PD Modification Application: PRS 26-0621 (Rev.)

**Hillsborough
County Florida**

Development Services Department

APPLICATION NUMBER: PRS 26-0621 (Rev.)

8.1 Approved Site Plan (Full)

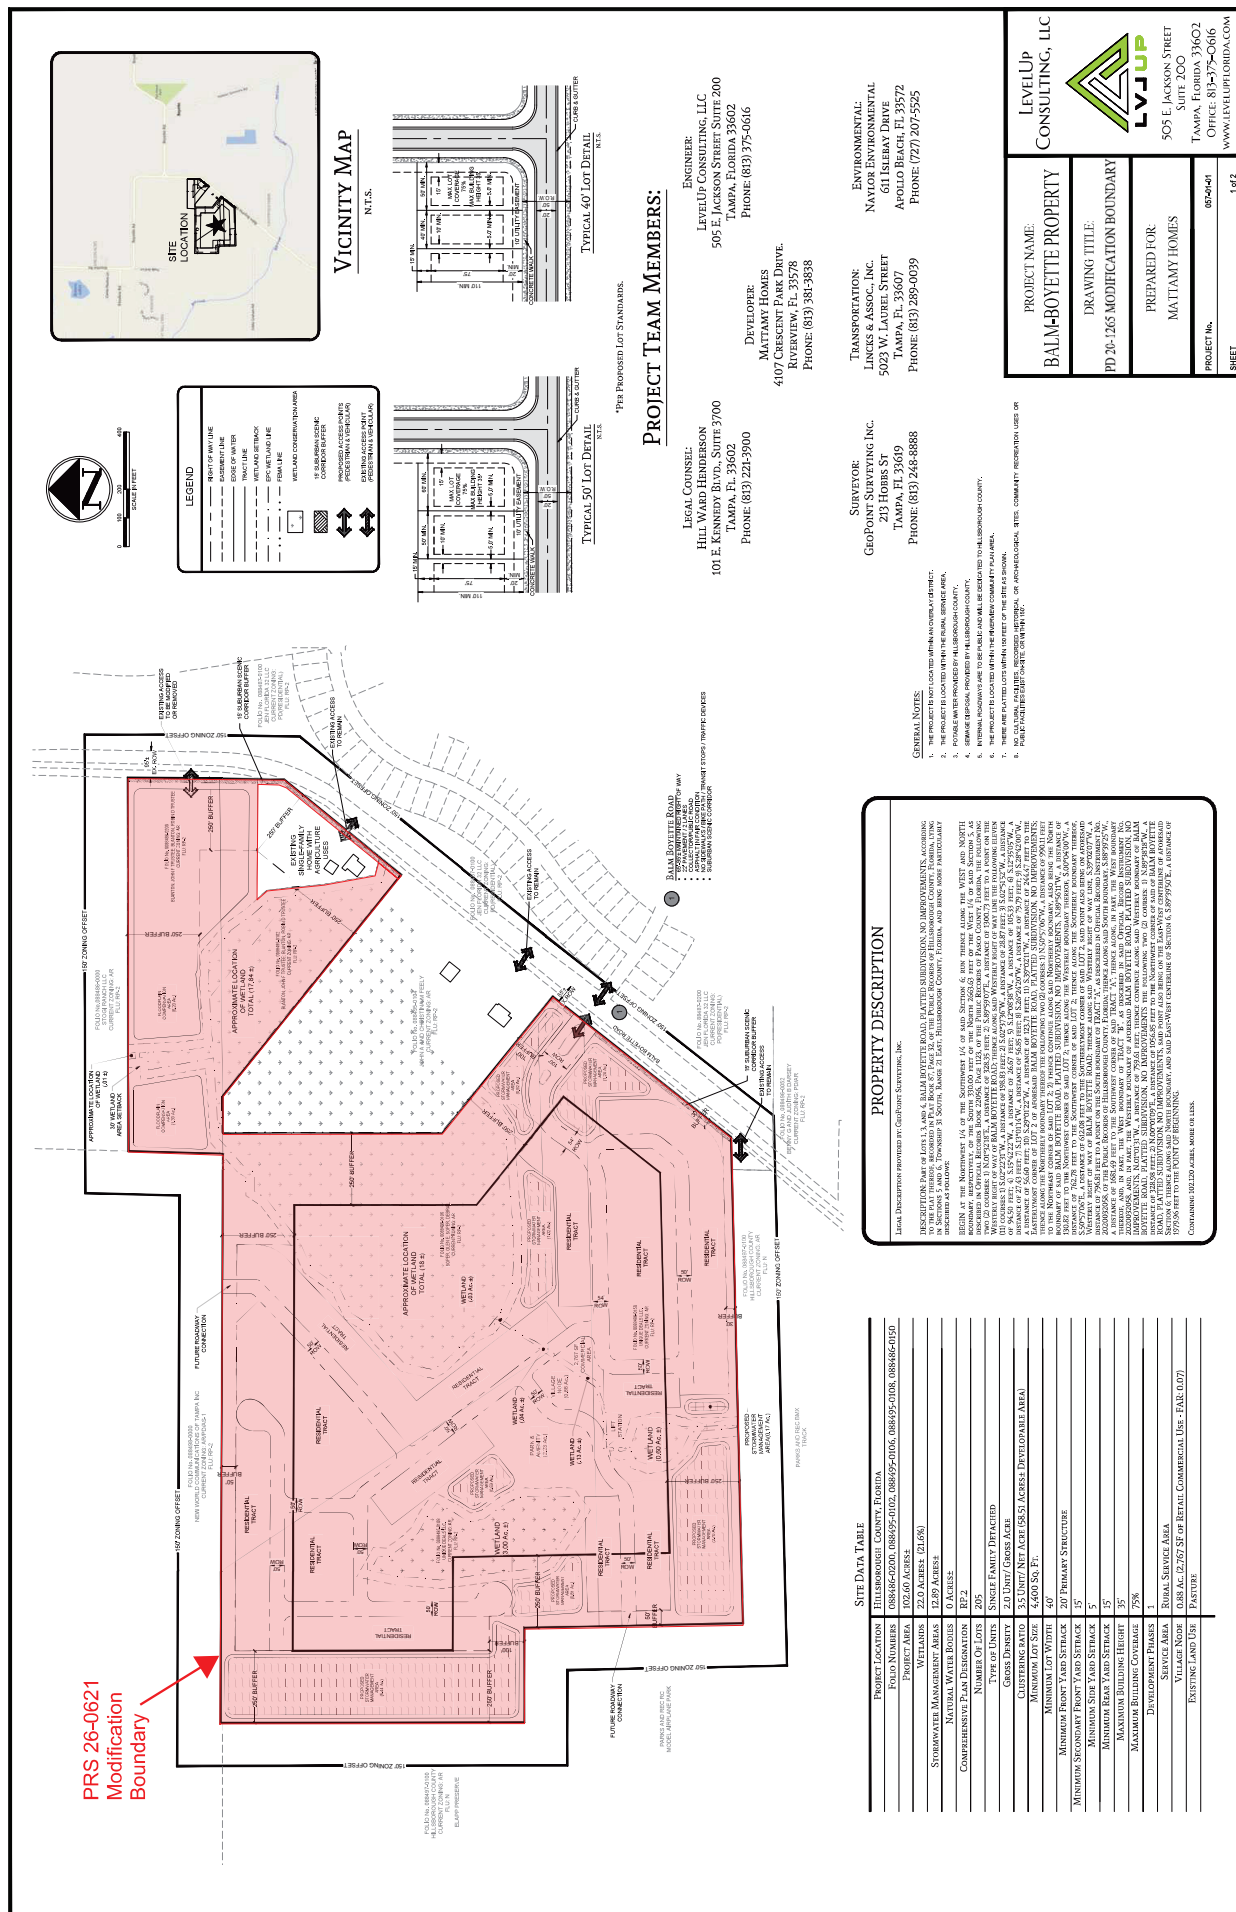
Along the project's western and southern boundary, the previously approved vehicular and pedestrian roadway stubout is proposed to be removed. The adjacent property is County owned (ELAPP) lands and according to the County Conservation and Environmental Lands Management Department there are no plans to accommodate a future roadway.

SITE PLAN ERROR- RC field to the west and BMX track to the south are both part of the ELAPP Preserve, Conservation & Environmental Lands Management Dept. There is no accomodation for a roadway into the Preserve from this development as indicated on the site plan.
